Existing Conditions Report: University Community Park Adventure Playground

KISHIMOTO ARCHITECTS, INC.

October 13, 2010

Photo Documentation

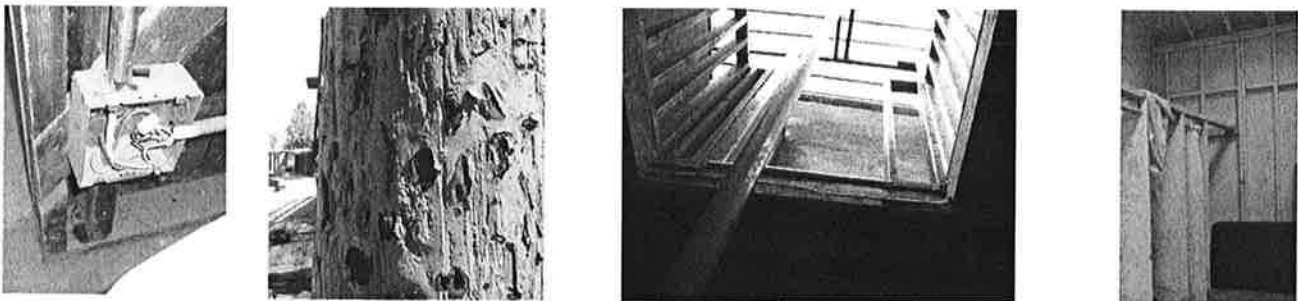
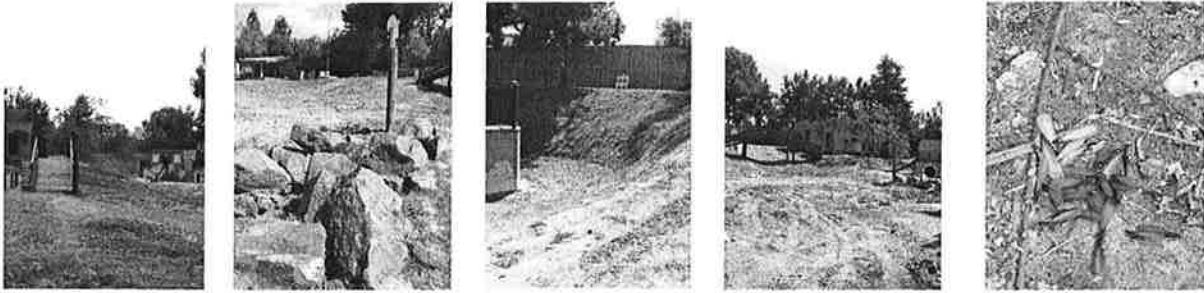
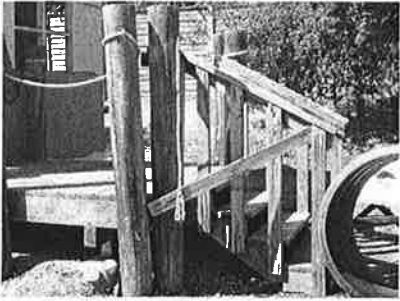
1. Non accessible access into buildings and play structures
2. Wood ramps with raised wood battens (some broken or missing) create a tripping hazard

1. Un-protected floor opening at second floor
2. Steep wooden stairs that do not have non-slip surface treatment on treads
3. No handrails on some stairs

4. Rough handrail/guardrail surfaces (potential for cuts and splinters)
5. Wood handrails that do not meet building code regulations
6. Wood ladders that do not properly extend above the second floor creating fall hazard

7. Loose guard rails on second floor play deck
8. Weathered plywood floors, walls and roofs (holes, sags, rot, mold, termite damaged, bird and rodent droppings)

9. Sub Subterranean termite nests
10. Exposed and rusted wood fasteners
11. Chipped and flaking paint
12. Exposed floor framing at some buildings (exposure to rusted wood fasteners)

13. No structural bracing on one and two story buildings
14. Exposed electrical connection at Mining Shack
15. Doors leading into Changing rooms are double swinging and do not have a view window

16. Insufficient ventilation in changing rooms

1. Flag pole with hard landing surface
2. Logs placed on end serving as steps to play structure (potential of fall and strike injuries)
3. Openings in chains supporting suspended bridge have potential for finger injuries
4. Cargo net has potential for injuries (choking, broken bones, etc.)
5. Wood post directly under sagging cargo net (strike hazard)
6. A 3 rope foot bridge has potential for fall injuries. Bottom of bridge is at least 5'-0" above the ground
7. Area under rope foot bridge is un-padded and un-defined
